**DRAINAGE LETTER
FOR
STERLING RANCH ROAD AND BRIARGATE PARKWAY INTERIM PLAN**

**March 11, 2021
Project No. 25188.03
PCD Filing No: CDR221**

**Prepared By:
JR Engineering, LLC
5475 Tech Center Drive, Suite 235
Colorado Springs, CO 80919
719-593-2593**

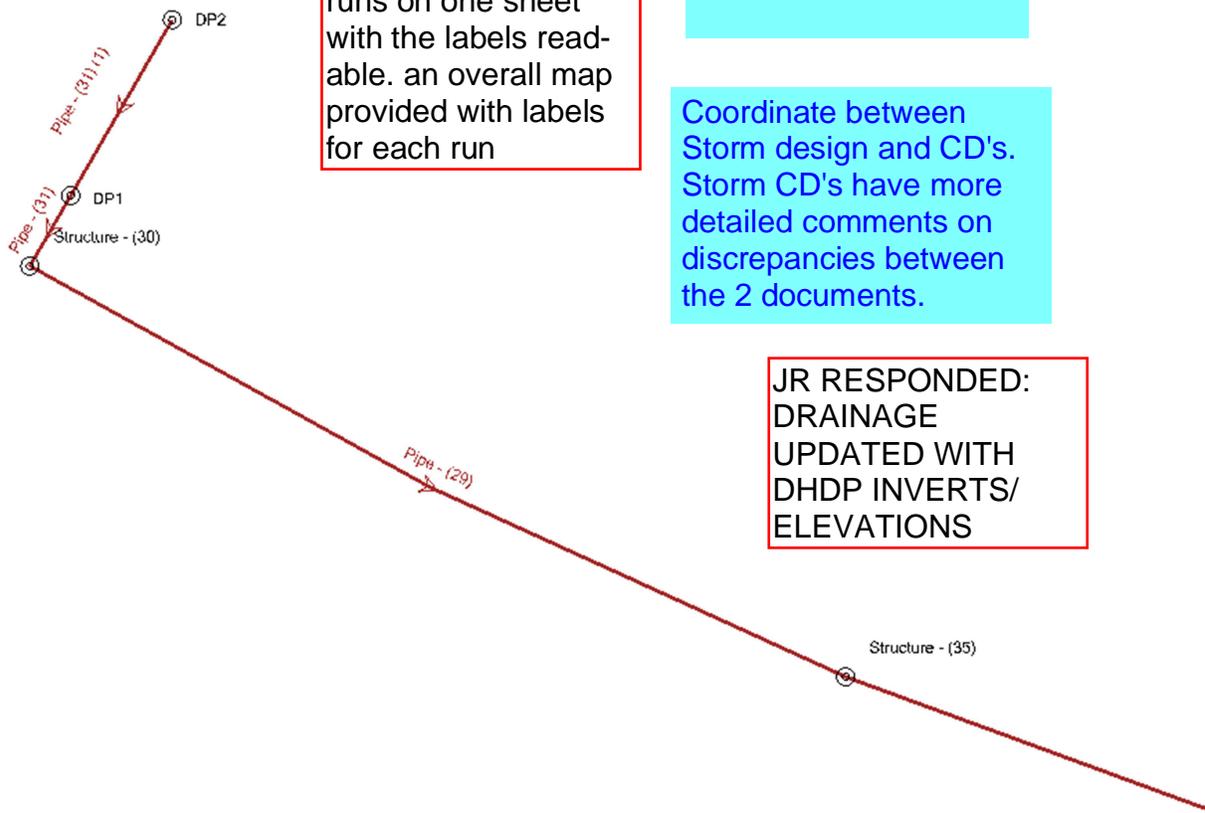
Each Storm Layout should be on single sheet.

Coordinate between Storm design and CD's. Storm CD's have more detailed comments on discrepancies between the 2 documents.

JR Response: it is hard to fit the long runs on one sheet with the labels readable. an overall map provided with labels for each run

Worksheet for Proposed Swale - Cross Section CC

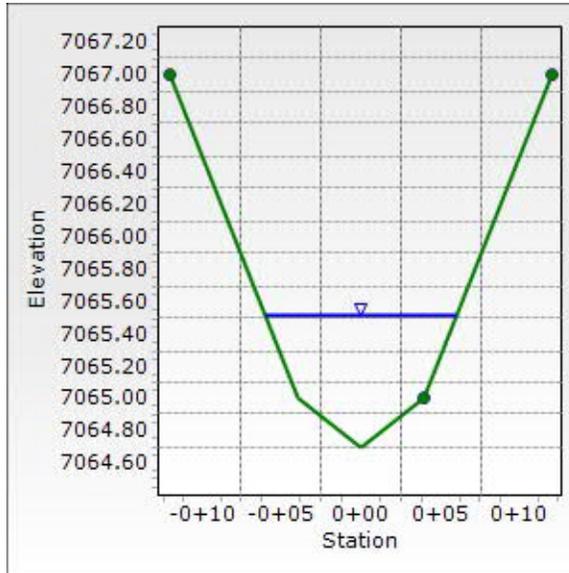
This section does not match swale section shown on drainage map. Please reconcile between the two and update.

JR UPDATED

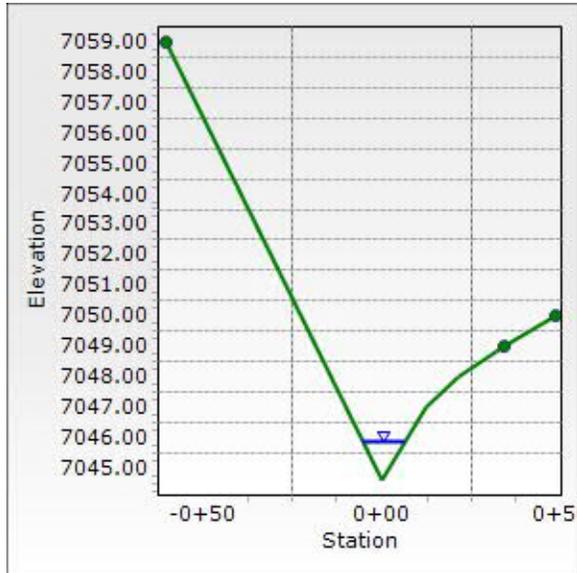
This section does not match swale section shown on drainage map. Please reconcile between the two and update.

JR RESPONDED

Section D JR RESPONDED.
B11 runoff added to total discharge

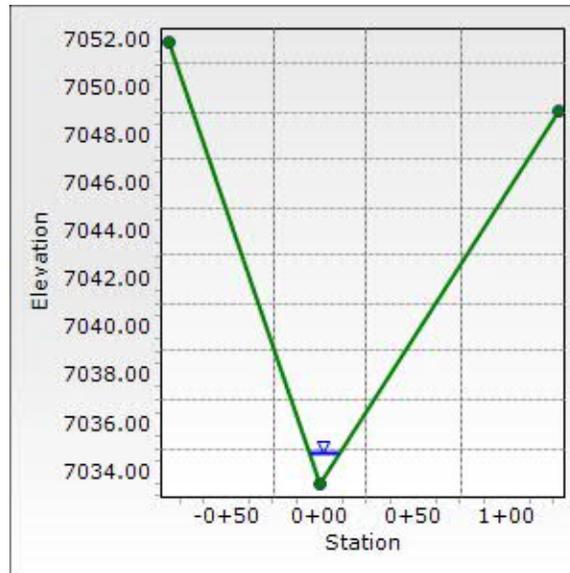
This section does not match swale section shown on drainage map. Please reconcile between the two and update.

JR RESPONDED

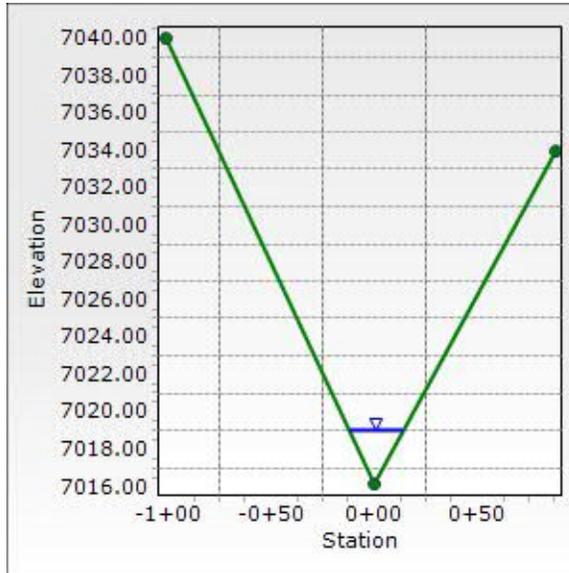
This section does not match swale section shown on drainage map. Please reconcile between the two and update.

JR RESPONDED

STERLING RANCH ROAD & BRIARGATE DRAINAGE MAPS
 EXISTING DRAINAGE MAP

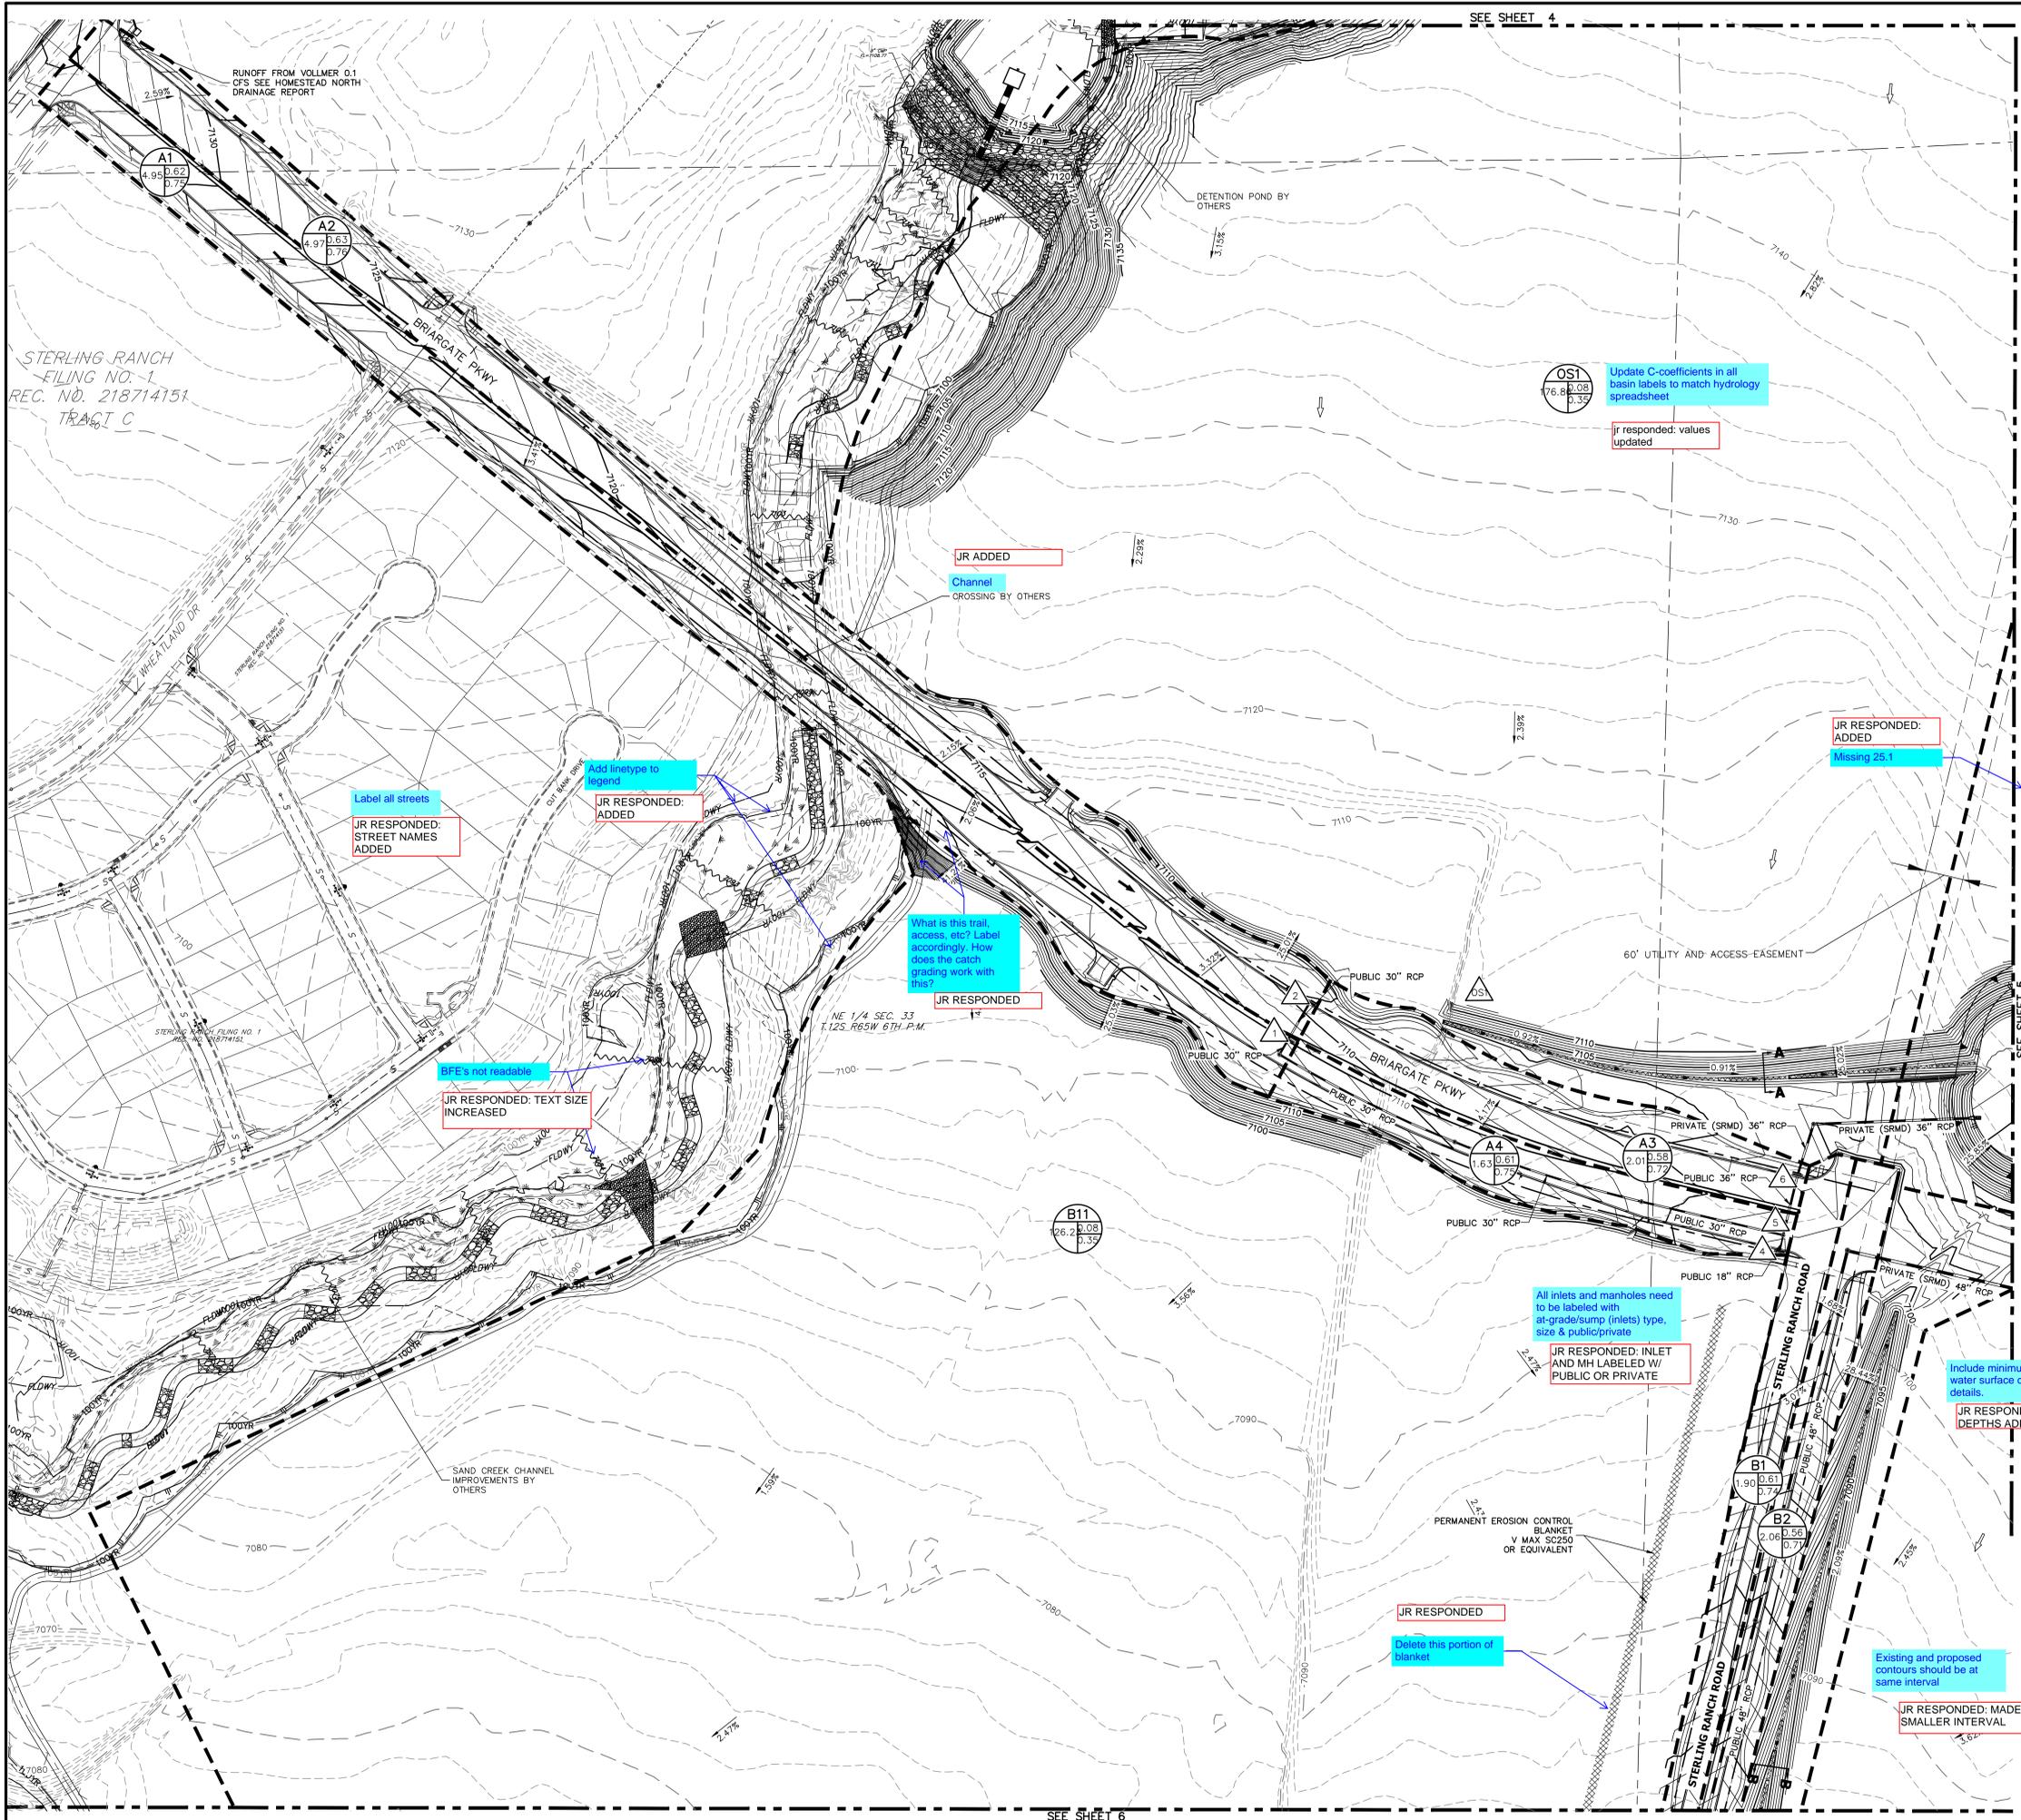
Update linetype to match plan
